SAFETY ALERT / SAFETY DIRECTIVE

SERVICE DOCUMENT SA 1_2017 Sky Arrow Issue 1		DATE 21st June, 2017	
APPROVAL REF.		<input checked="" type="checkbox"/>	<input type="checkbox"/>
		CHANGE / REPAIR	
SUBJECT: NOSE LANDING GEAR WITH BERINGER WHEEL			
APPLICABILITY: SKY ARROW LSA SERIES			
This Service Document is:			
<input checked="" type="checkbox"/>	MANDATORY (1)	<input type="checkbox"/>	RECOMMENDED (2)
		<input type="checkbox"/>	OPTIONAL (3)
<ol style="list-style-type: none">1. Failing to comply with the mandatory Service Document may immediately get the aircraft not airworthy.2. Failing to comply with the recommended Service Document does not directly reduce the flight safety of the aircraft.3. Failing to comply with the optional Service Document does not affect the safety of the aircraft. Compliance improves the comfort or the performance of the aircraft.			
COMPLIANCE TERMS: This Service Document is MANDATORY			
STATEMENT / ADDITIONAL NOTES: The technical content of this document is issued under the alternative procedure to DOA ref. EASA.AP180, approved by EASA.

5. UPDATING OF NOSE LANDING GEAR INSTALLATION

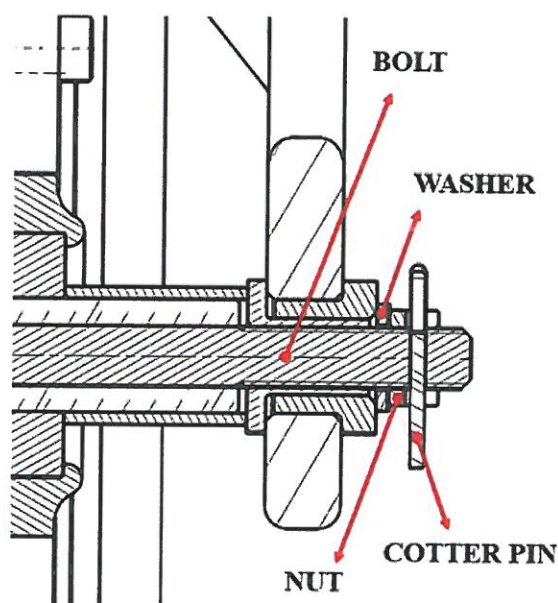
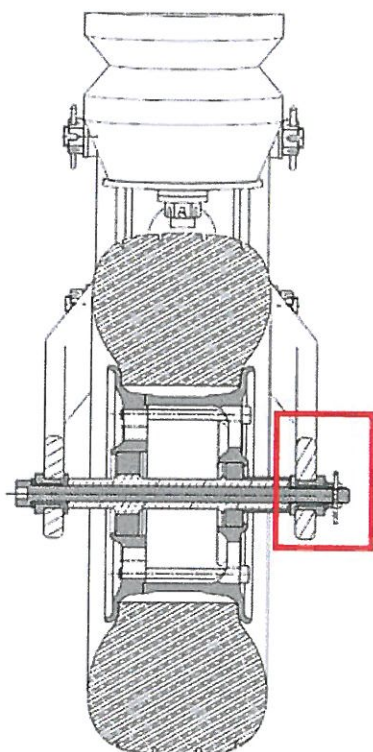
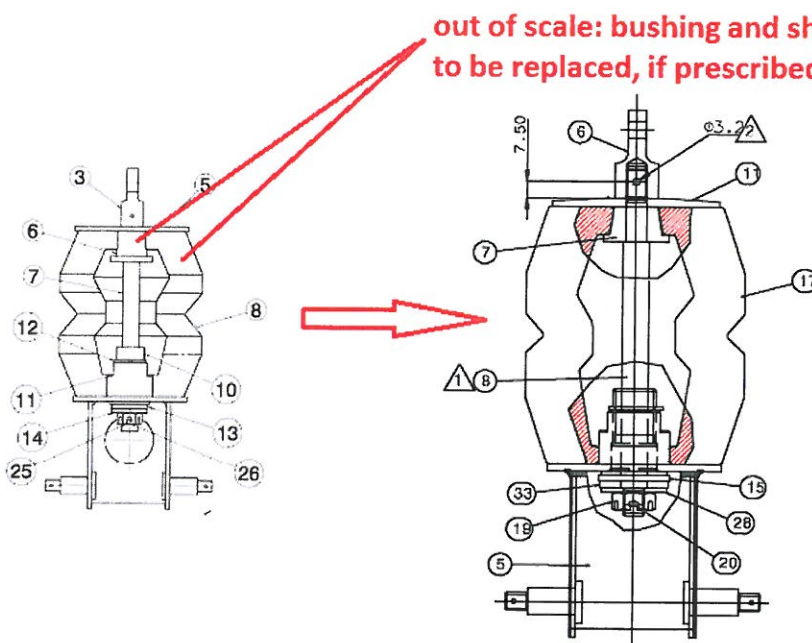
- the NLG bolt, nut and washer Beringer part number AXP-003.1 (part of kit coded 12COPM401) must be replaced with newer axle (with longer shank), nut, washer, cotter pin parts;
- if applicable, according to the serial number of the affected aircraft, Magnaghi shall also prescribe the replacement of shock absorber R01010-35/01 (coming from Angst Pfister EE 132/110 A, part number 12.2102.0315) with part number R01010-35/00 (coming from Angst Pfister EE 130/100 B, part number 12.2102.0314).

Job must be performed according to prescriptions at Section 32 of Airplane Maintenance Manual, rev. 1 dated 15th June, 2015 or following.
